NOTIFICATION OF ADDENDUM
ADDENDUM NO. THREE
DATED: August 21, 2021

PR South, Inc. on behalf of Northwest Williamson County Municipal Utility District No. 2
Cottages at Parmer Ranch
City of Georgetown Williamson County, Texas

SEWER LINE A PLAN & PROFILE
for
THE COTTAGES AT PARMER RANCH
City of Georgetown ETJ
Williamson County, Texas

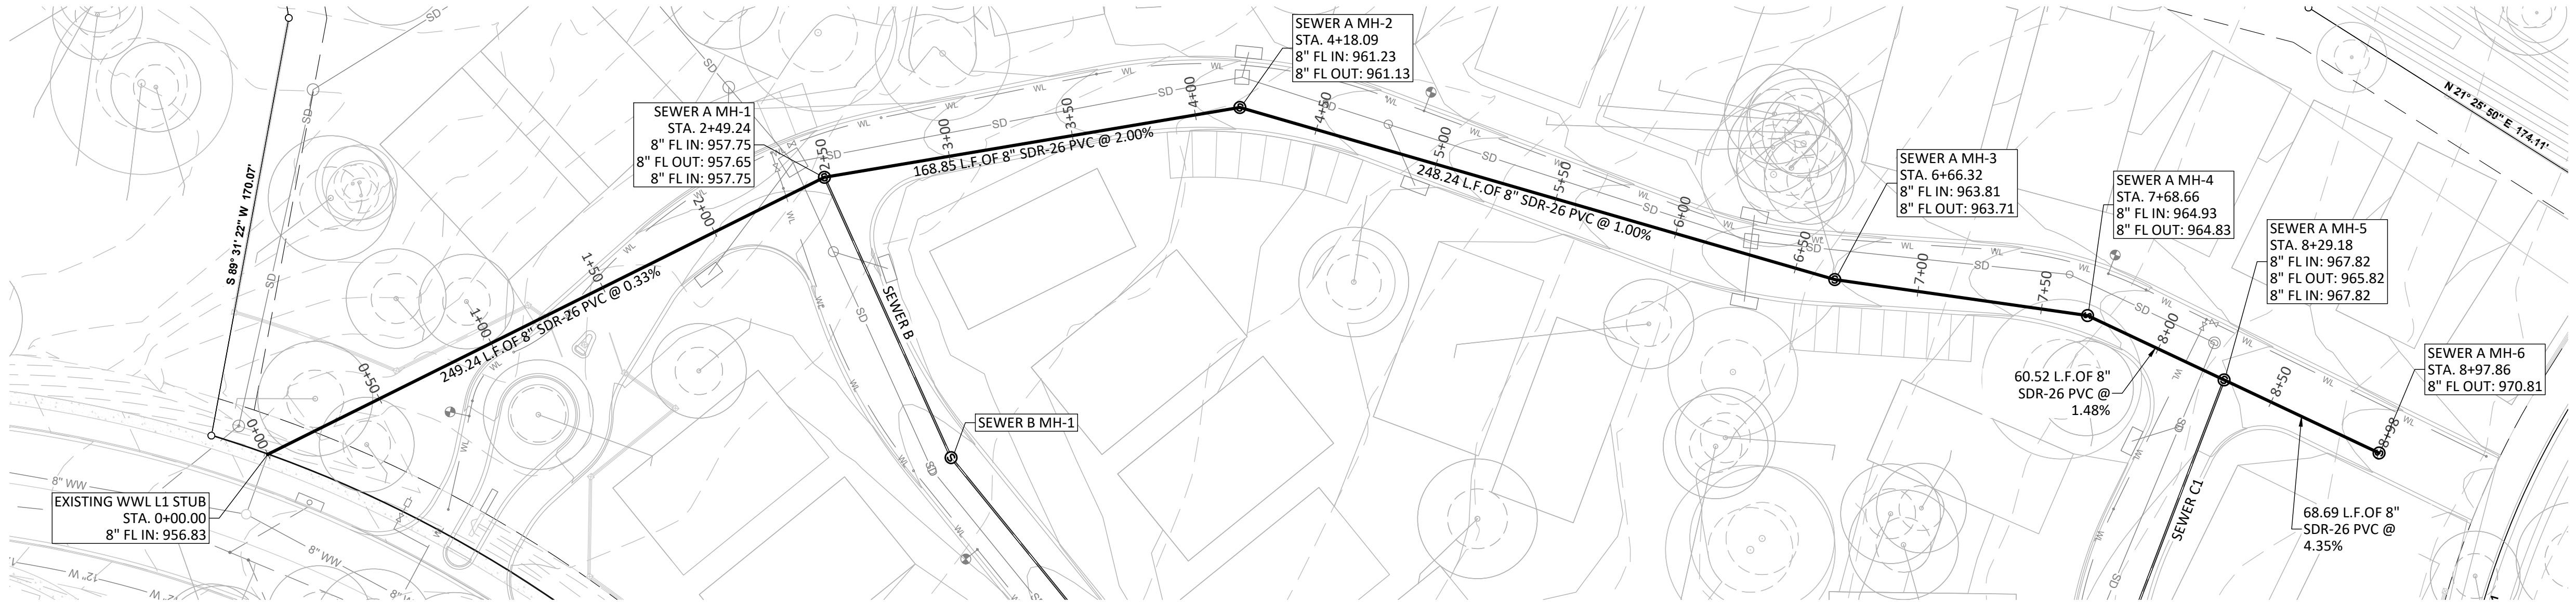
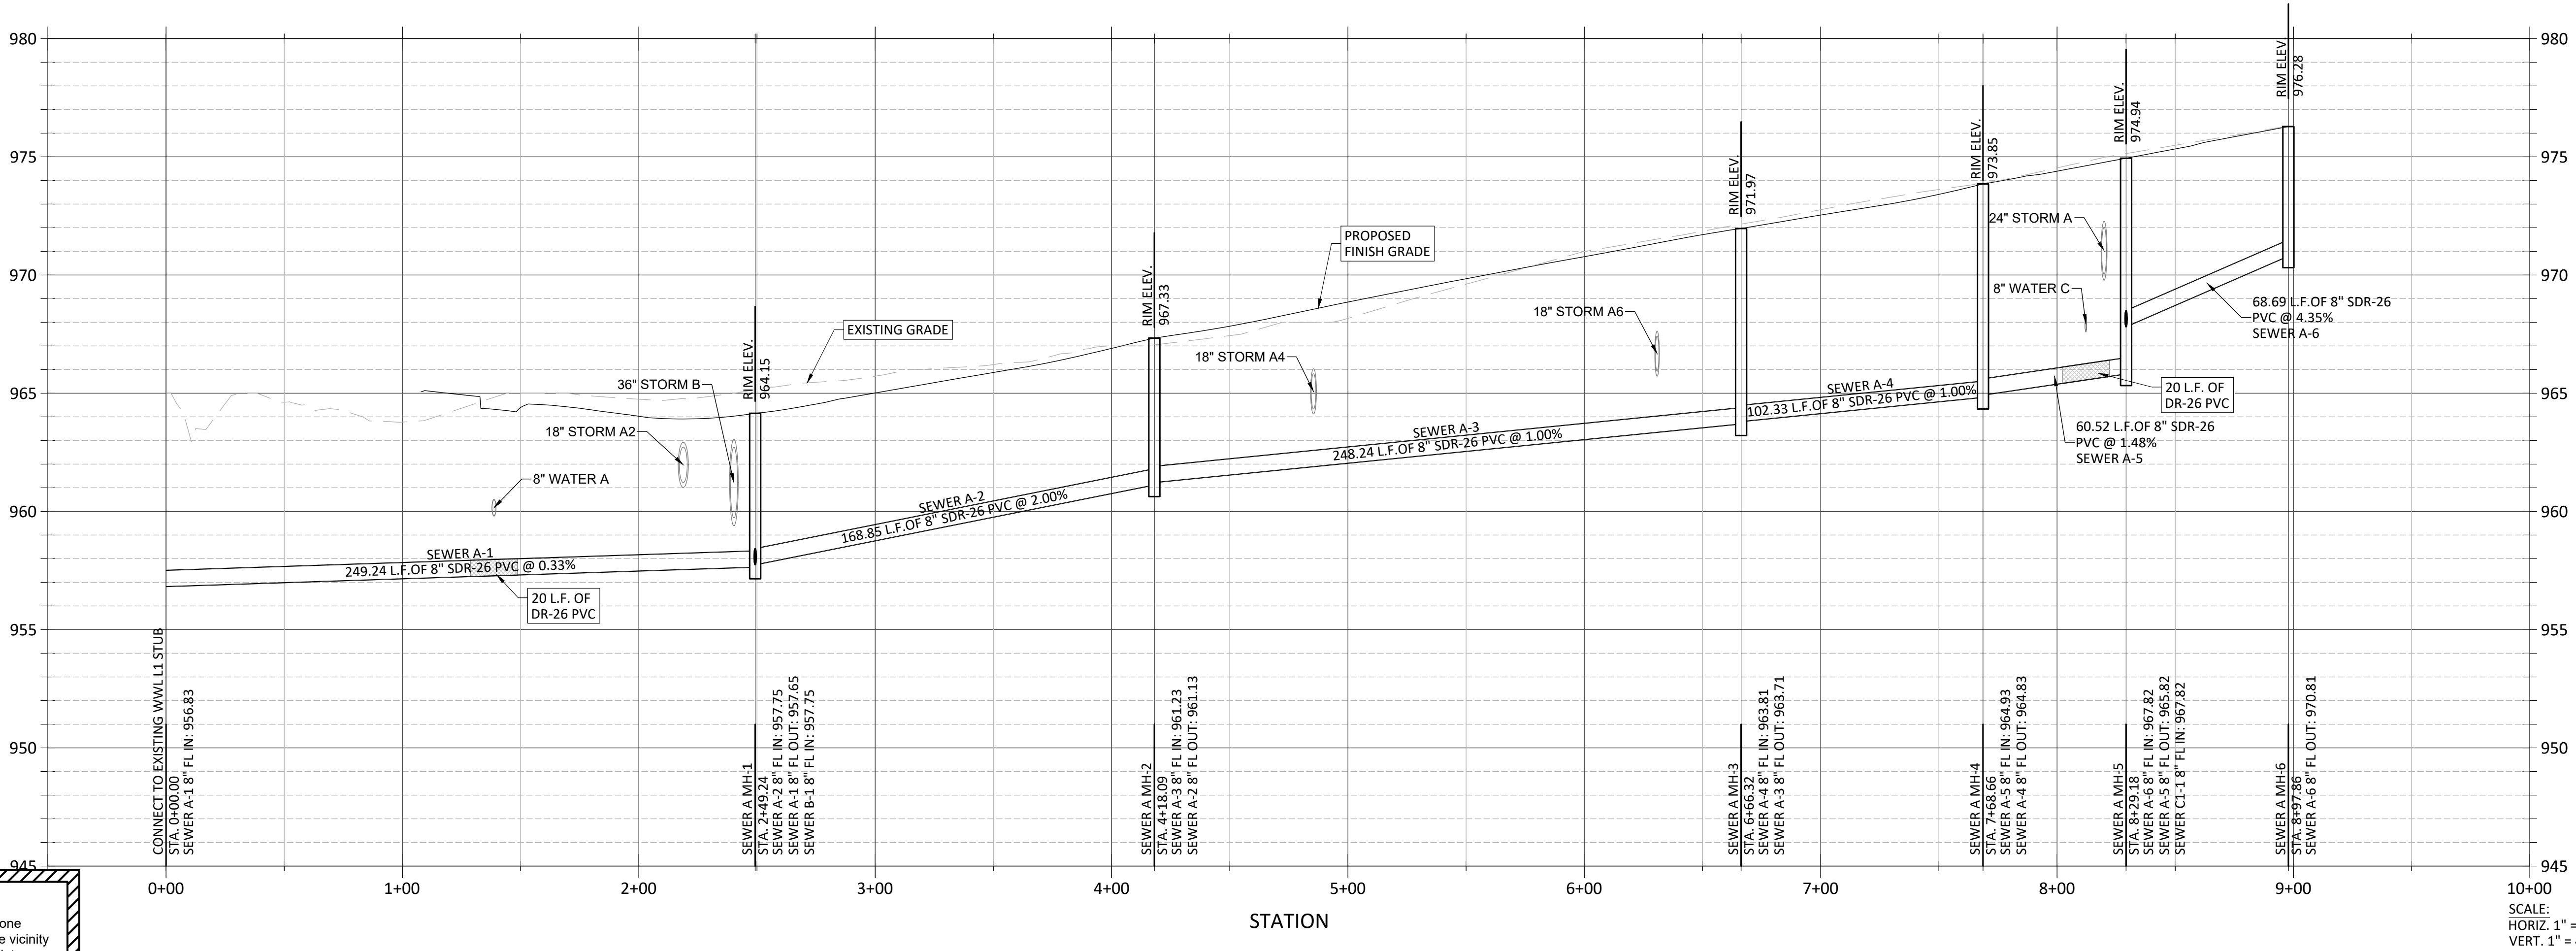
17. Bid form calls for 60 L.F. of 8" DR-18 but no callouts. Please clarify. Is there trench safety for this?
 - a. Callouts have been added to the plans at intersections of water and wastewater.

- b. Trench safety includes this trench as it is a segment of pipe. Sewer lengths have been updated.
18. Please verify 4" mountable curb quantity.
 - a. The bid form has been updated 5,984 L.F.

STRIPING & SIGNAGE PLAN
for
THE COTTAGES AT PARKER RANCH
City of Georgetown ETJ
Williamson County, Texas

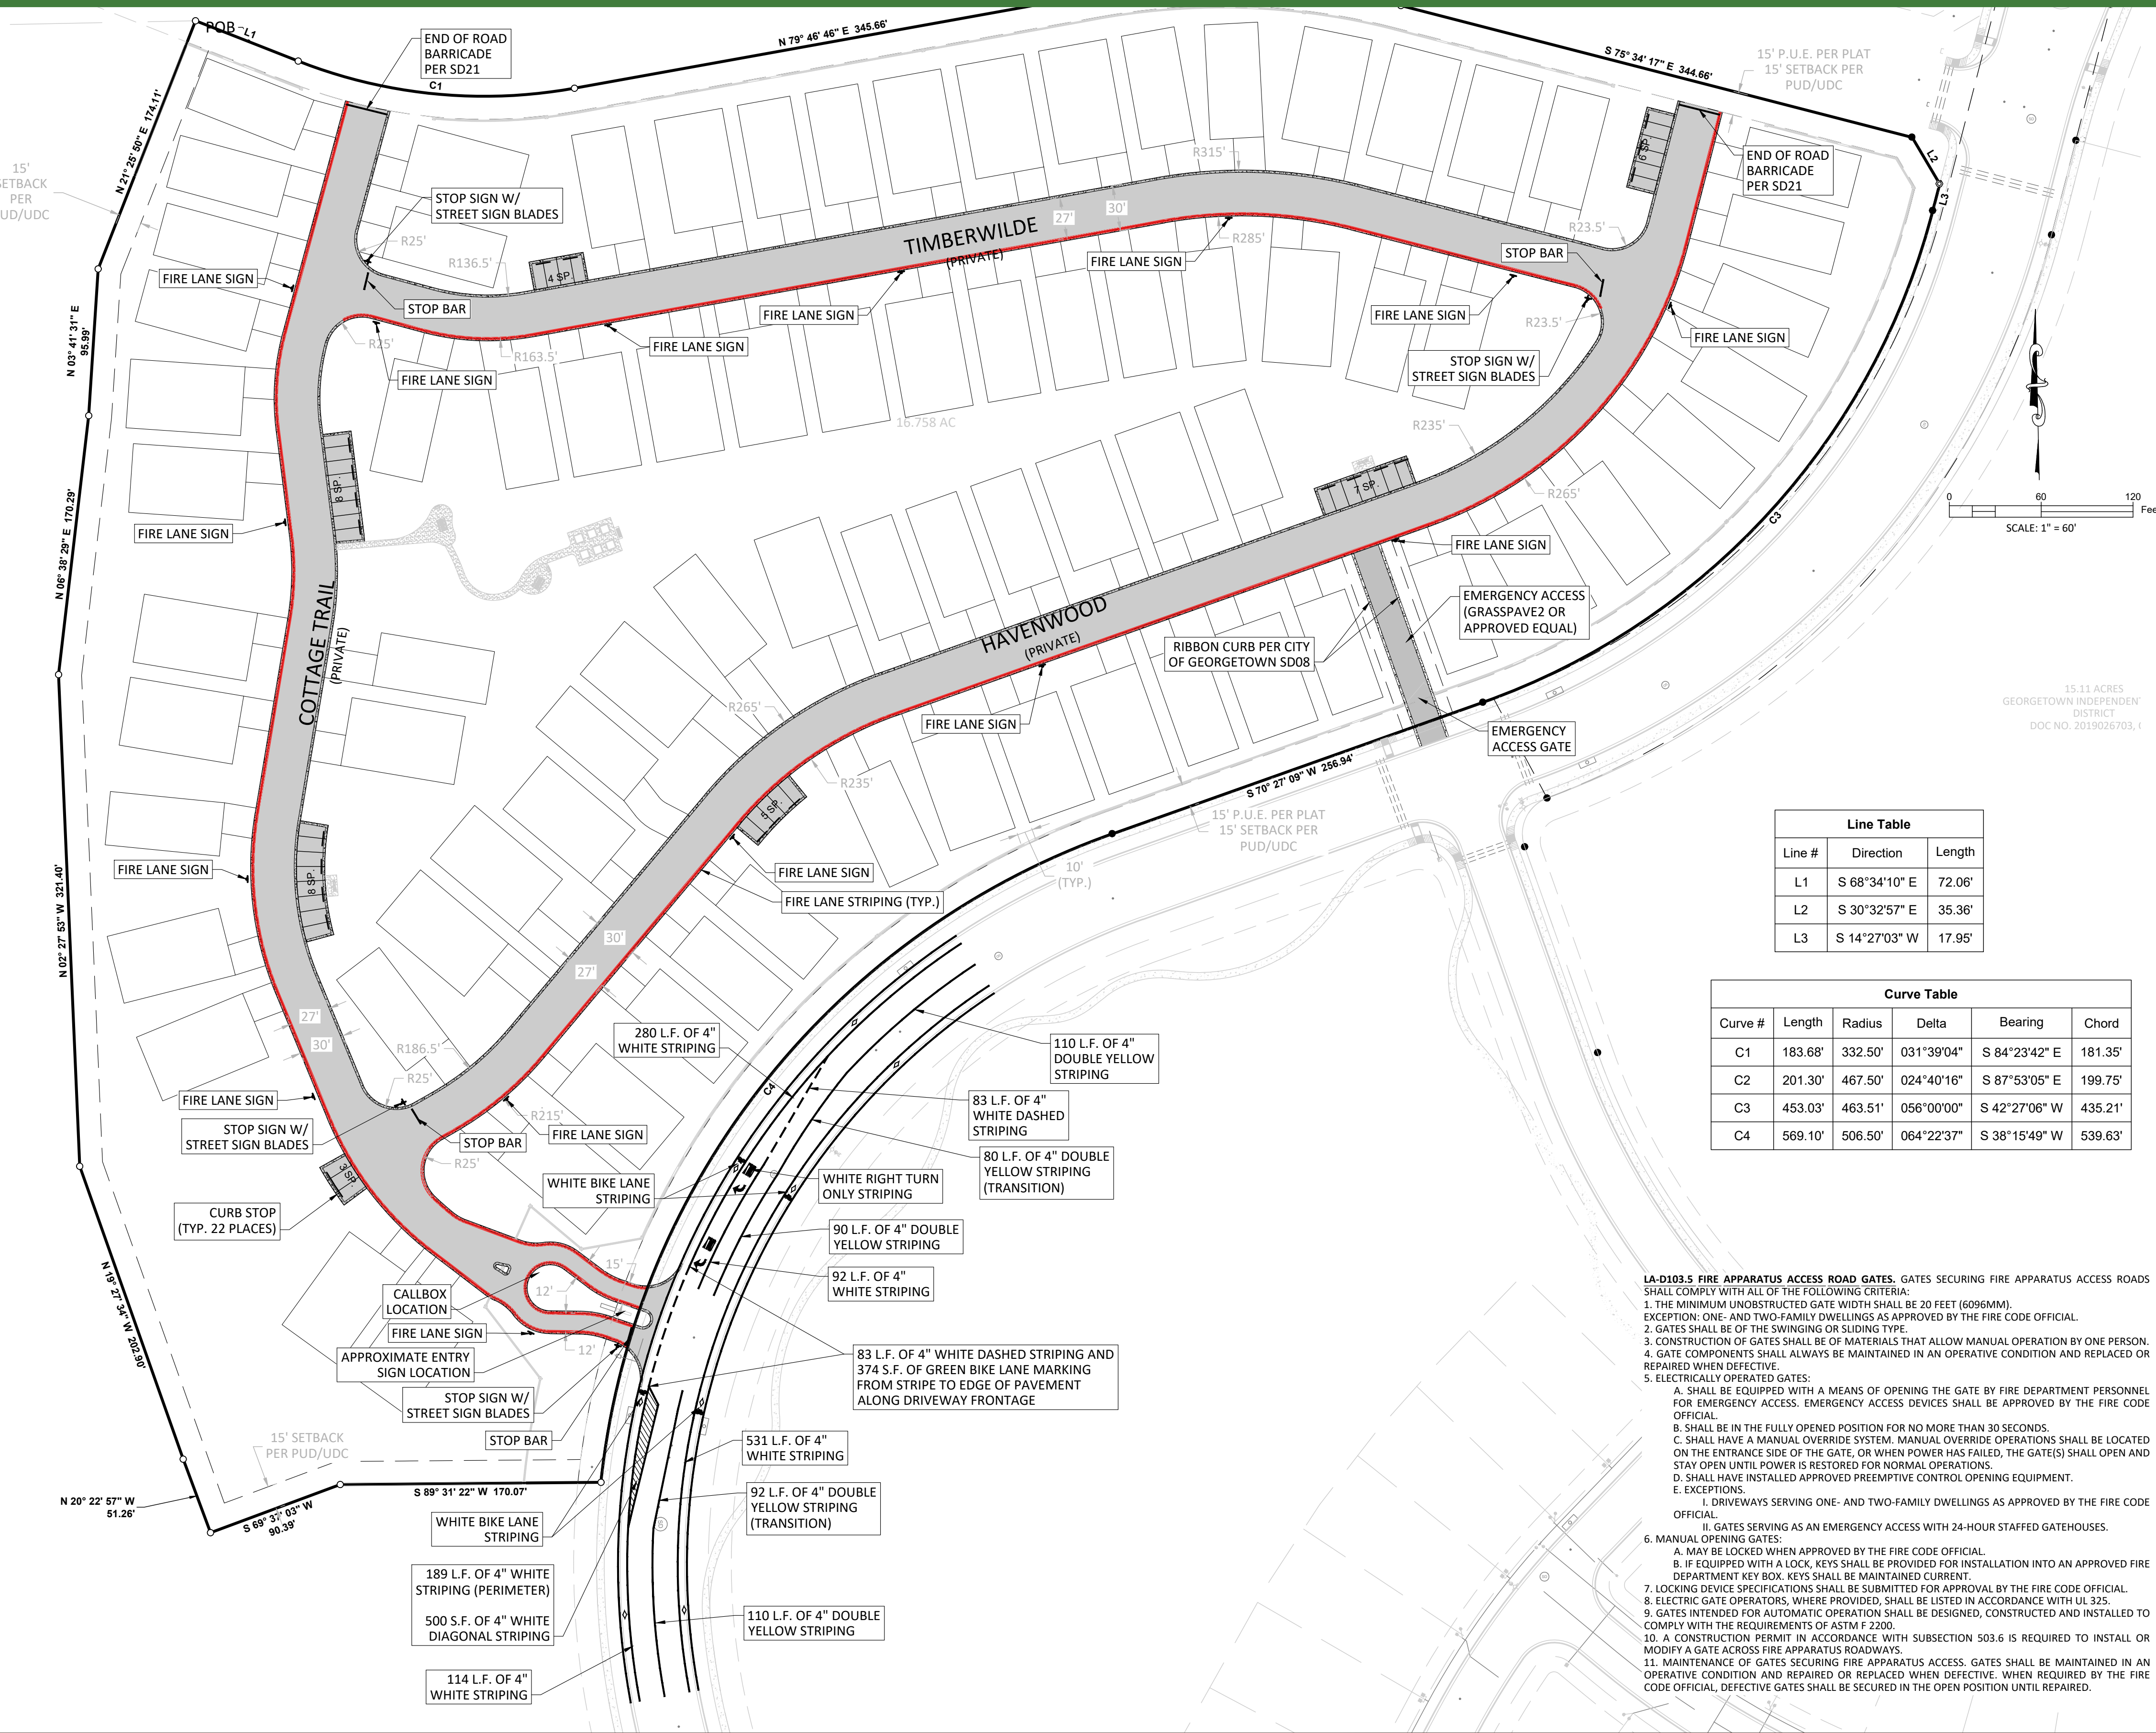
9. There are no tree wells on the bid tab, please advise.
 - a. An item has been added to the bid form for tree wells.
10. On Striping and Signage sheet, what are the limits of striping on Parmer Ranch Boulevard for the project?

- a. The project is adding a right turn only lane which includes a transition area before and after the entrance. Quantities of the striping have been included on the sheet and a bid item has been added to the bid form.
